Subject: Submittal of Modified Plans and Revised Technical Materials
"Form B" Application for Approval of a Definitive Subdivision Plan
42 (Rear) 48 (Rear) and 54 (Rear) Skyline Drive Properties and 20 Davkim Lane Property
(Planning Board File # 7918)

Definitive Subdivision Plan (Revised) Submittal
June 3, 2016
Page Two

**REQUESTED WAIVERS
CLAY STREET
NANTUCKET, MASSACHUSETTS**

Storm Water Management Report

**DEFINITIVE INDEX SHEET
 CLAY STREET
 NANTUCKET, MASS.**

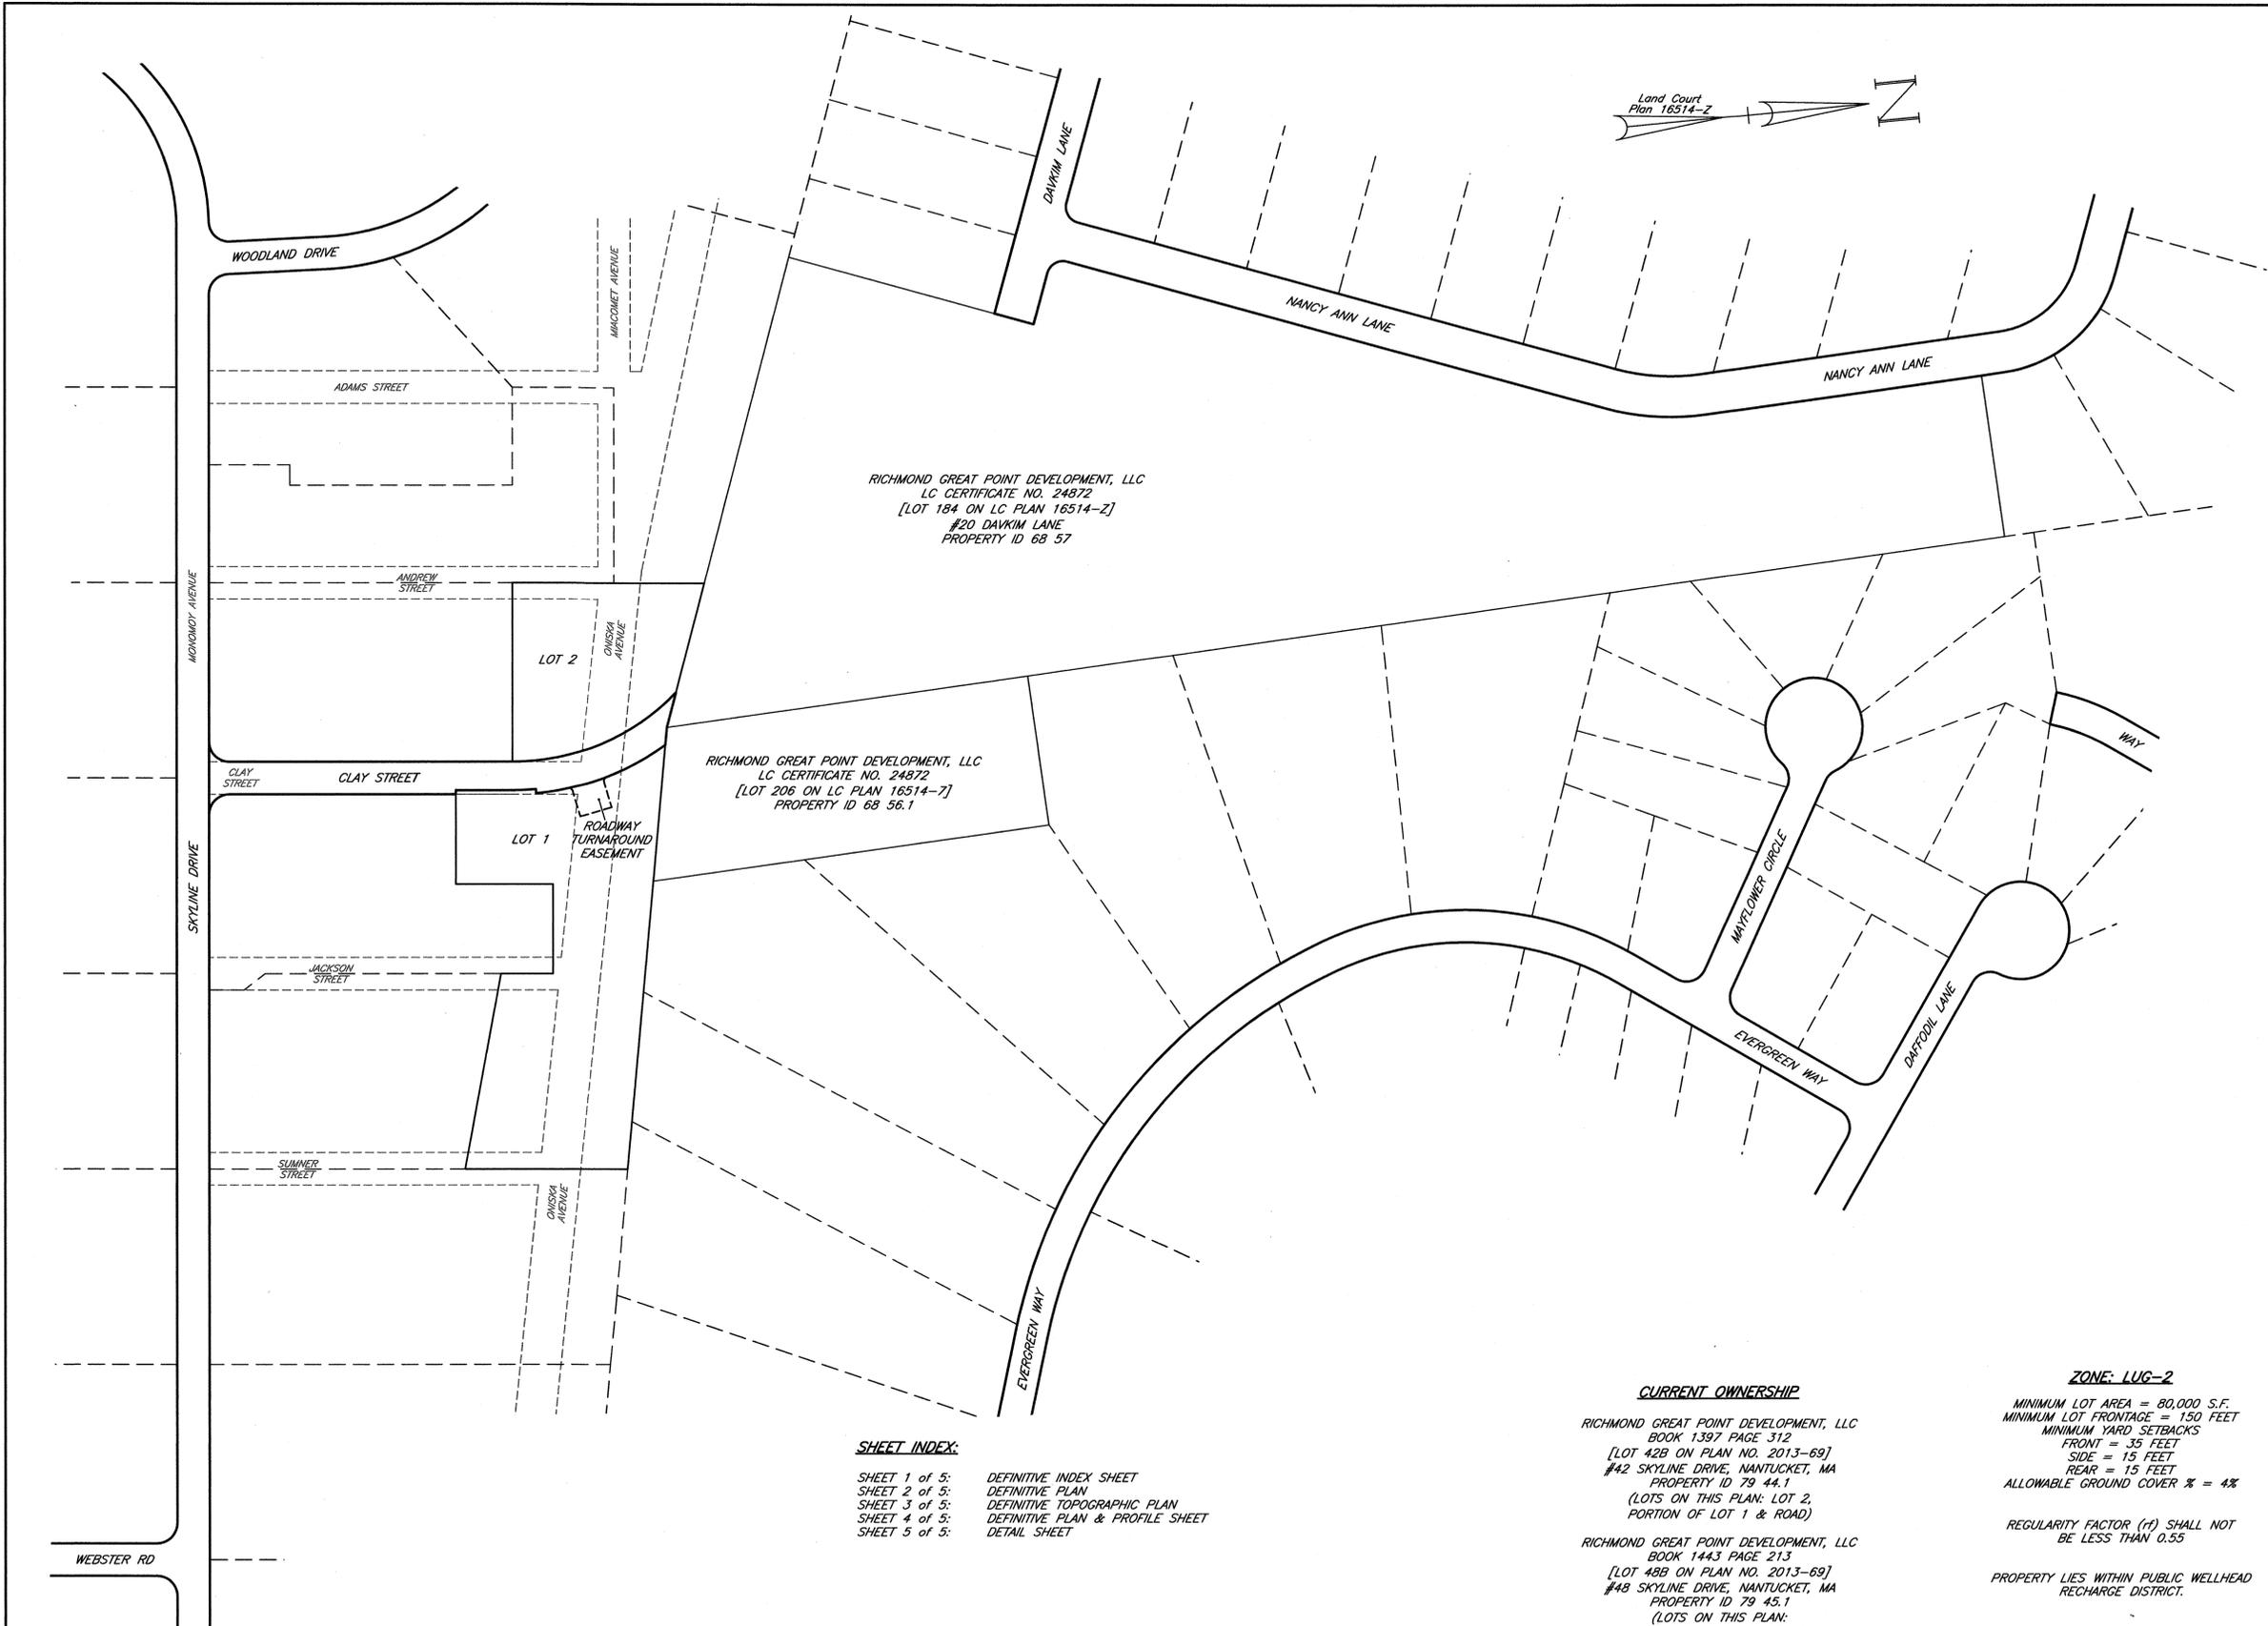
- The right of way of the proposed road, shown as "Clay Street" on the subdivision plan, now terminates at the property line / boundary between the 48R / 42R Skyline Drive properties and the 20 Davkim Lane property and does not continue into or through any portion of the 20 Davkim Lane property.
- The proposed improvements within the "Clay Street" right of way have been minimized and are comprised of a 12 foot wide gravel road that transitions into a 17.5 foot wide "hammerhead / turnaround" solely to provide access to the 48R / 54R Skyline Drive property (essentially meeting the standards for driveways set forth in the local subdivision rules and regulations).

10		
9		
8		
7		
6		
5		
4		
3		
2	Reduced scope of subdivision plan	5/31/2016
1	Ownership & obutter references	2/29/2016
No.	Revision	Date
